Reviewers' comments:

Reply to Referee Report of the manuscript

Gate-reflectometry dispersive readout and coherent control of a spin qubit in silicon

by A. Crippa et al.

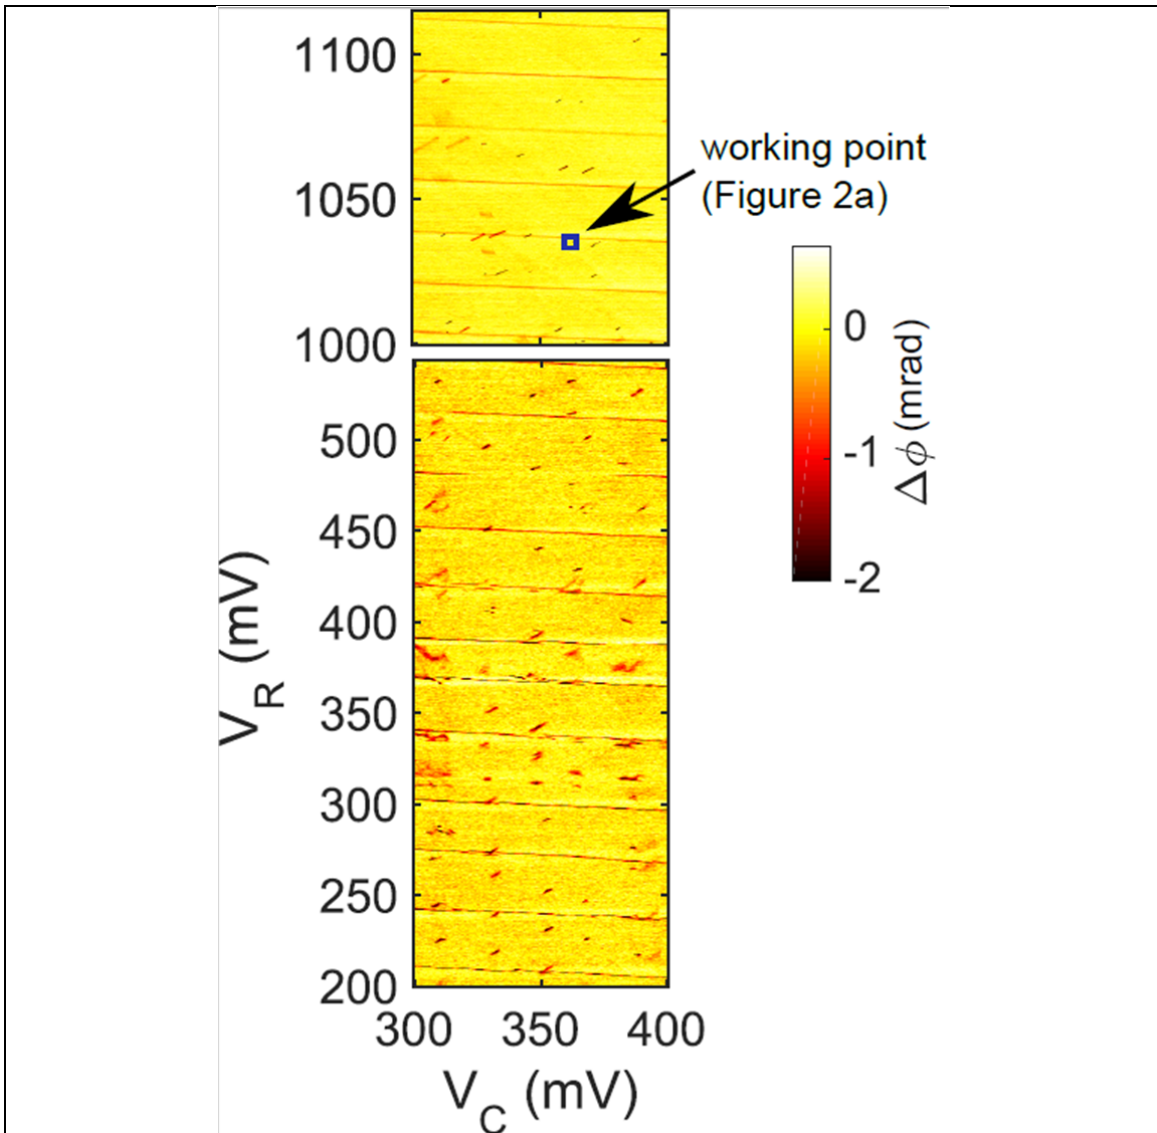
2. The double dot system is operated between “(0,2)” to “(1,1)” states, with the actual number of holes not known accurately. The authors are up-front about this, and I do not see this as a problem, since it doesn’t detract from the significance of the result. However, the authors should include a charge stability map (extending that in Fig. 2a) showing the nearby charge states, so that the reader can assess for themselves the level of disorder in the system. Such a plot could be presented in the Supplementary Material.

We accede to the Reviewer’s request. The new Figure S2 in the Supplementary Material shows a larger portion of the gate voltage space spanned by V_C and V_R . Comments to this figure are reported in Supplementary Note 2 of Supplementary Material and here below:

“Supplementary Figure S2 shows two stability diagrams of the device under investigation. Both plots share the same V_C voltage range. The other gate tunes the electrostatics of the channel from the many hole regime (bottom panel) to the voltage region we use to implement our qubit (top panel). In particular, the blue square highlights the area zoomed in the stability map of Fig. 2a in the main text.

Considering the diagram as a whole, two sets of features are present. First, a series of nearly horizontal parallel lines are visible. These lines repeat quite regularly from metallic DQDs to depletion, even the silicon channel is completely closed (data not shown). Consequently, we speculate that these features are related to the charging of objects extrinsic to the channel.

On top of this background, most of the short diagonal cuts on the yellow background are interdot transition lines.

The bottom part of Fig. S2 reports the many hole regime where the voltage spacing between DQDs is approximately constant. The typical gate voltage between two charge states is about 25 mV. This value is consistent with other experiments on similar samples [1, 2].

Out of the many hole regime, the interdot lines are unevenly spaced, as displayed in the top panel. Importantly, for interdot tunnel couplings of few GHz (like the one studied in the main text), the interdot transition lines are quite thin in gate voltage, and are very likely not resolved in large maps obtained with large voltage steps.

We use the threshold voltages at room temperature of the two gates and the addition voltage of the many hole regime for a rough estimation of the absolute filling of the dots. We obtain an order of magnitude of 5 holes and 10-20 holes in the left (i.e. mainly controlled by V_R) and right dot (mainly controlled by V_C), respectively.”

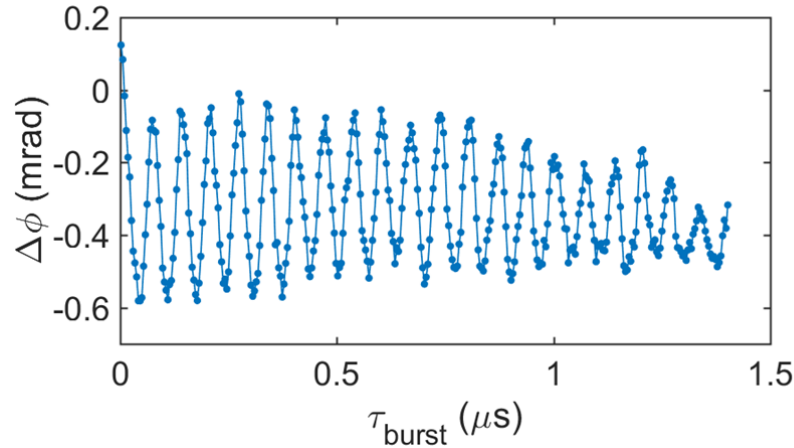
8. On a related note, in Figure 4d, why did they stop taking data at 1.2 us burst length? What does the data look like up to 2 microseconds? This would give a clearer idea of the decoherence

mechanism.

Data have been recorded only up to 1.4 μs burst length, as shown in the plot below. The visibility is further reduced from 1.2 μs to 1.4 μs , but without suggesting any evident functional form of the envelope.

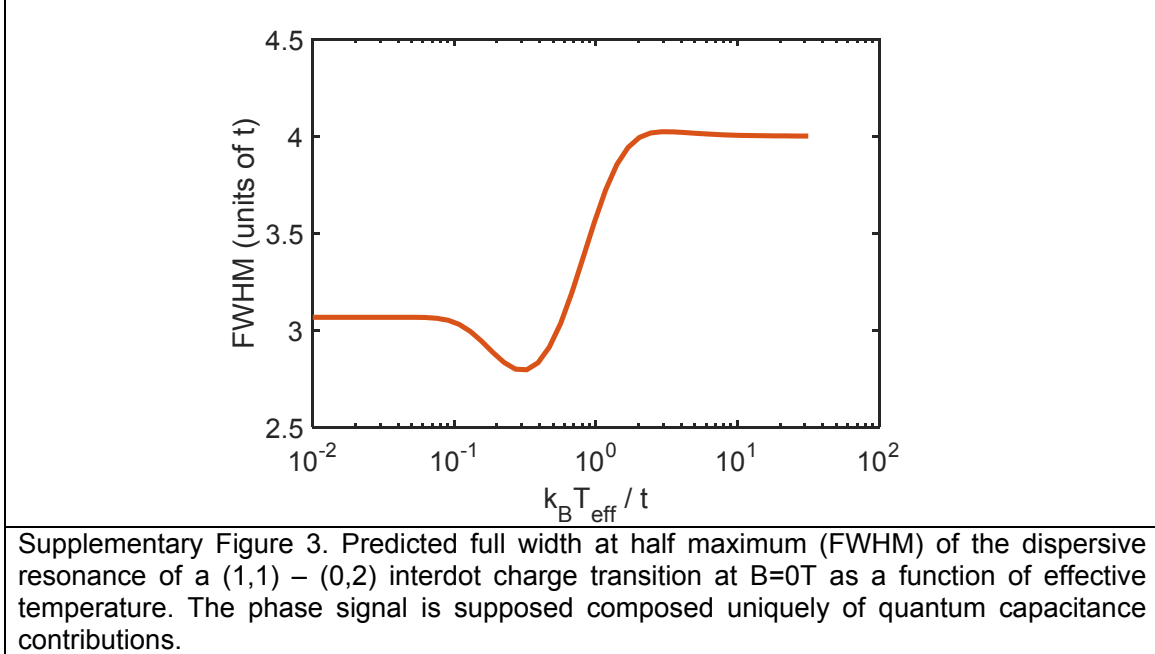
2. The electronic temperature is stated to be 250 mK, corresponding to an energy of 22 micro electron-volt. How was the smaller tunneling coupling energy deconvoluted from the thermal broadening when using the data of Figure 2a? In usual charge sensing, the inter-dot charge transition always has a temperature broadening associated to it.

According to simulations at 0 Tesla of a $(1,1) - (0,2)$ interdot charge transition, the impact of T_{eff} on the dispersive signal by gate reflectometry is twofold. The amplitude of the phase shift diminishes by increasing T_{eff} . However, contrarily to an interdot signal probed by a charge detector, the full width at half maximum (FWHM) doesn't increase monotonously with T_{eff} . This is linked to the sensitivity of the resonator, ultimately constrained to the detuning region where the DQD states have finite curvature (if the phase signal is supposed composed uniquely of quantum capacitance contributions).

In the revised manuscript we have added Supplementary Information (Note 3) to clarify this concept. Supplementary Figure3 shows the evolution of the FWHM of the interdot phase

signal as a function of the thermal energy $k_B T_{\text{eff}}$ normalized by the tunnel coupling t . The FWHM values are in units of t .

“Two limiting situations are envisaged. At low temperature, $k_B T_{\text{eff}} < t/10$ and the width of the interdot signal is set by the tunnel coupling to $\sim 3t$. Here just the ground singlet is populated. In the opposite limit of high temperature, $k_B T_{\text{eff}} > 2t$, the threefold triplet and both bonding and anti-bonding singlet are thermally populated; by sweeping T_{eff} , the magnitude of the interdot resonance drops, but the FWHM saturates at $\sim 4t$. In the intermediate regime, the FWHM increases progressively with T_{eff} , up to the saturation point occurring at $k_B T_{\text{eff}} \simeq 2t$.”

Furthermore, Supplementary Figure\,\ref{fig:Fig3S} demonstrates that the FWHM allows to estimate t in the $(3t, 4t)$ range whatever the temperature is. This distinguishes dispersive readout from charge sensing (especially when $k_B T_{\text{eff}} > 2t$), as the resonator sensitivity is ultimately constrained to the avoided crossings in the energy level diagram.

Fits to the interdot detuning phase shift yield $t=8.5\,\mu\text{eV}$ and $t=6.4\,\mu\text{eV}$ in the low and high temperature limit, respectively. The evolution of the interdot transition line versus the magnetic field is reproduced qualitatively assuming the lowest tunnel coupling and $0.25\,\text{K}$ as effective temperature.”

Coming to the point arisen by the Reviewer, the stated interdot tunnel coupling (7 ueV) has been extracted from the FWHM of the interdot transition line at 0 Tesla from $t = (t^{\text{HIGH}} + t^{\text{LOW}})/2$, where t^{HIGH} (6.4 ueV) and t^{LOW} (8.5 ueV) have been evaluated in the high T and low T limit, respectively.

We realize now that this claim is maybe too simplistic. We have amended the paragraph in the main text as follows (line 127):

“We estimate t between 6.4 and 8.5 μeV , depending on whether thermal fluctuations contribute or not to the dispersive response (see Supplementary Note 3).”

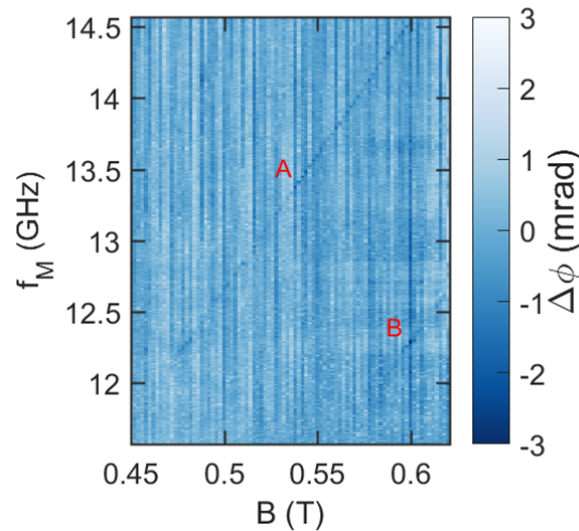
3. I can appreciate the hard work involved but why not showing the EDSR resonance of the other dot?

We didn't manage to find a condition for which both the EDSR resonances were visible and of publication quality. Yet we report here a map $|B|$ vs microwave frequency for the orientation of the field used in the qubit dataset shown in the manuscript. A 90 ns microwave burst was applied during a pulse of 250 ns with a 1/3 duty cycle. Two lines can be distinguished, marked as A and B. Line A shows the strongest dispersive signal and corresponds to spin flips in the left dot; line B is related to spin flips in the right dot.
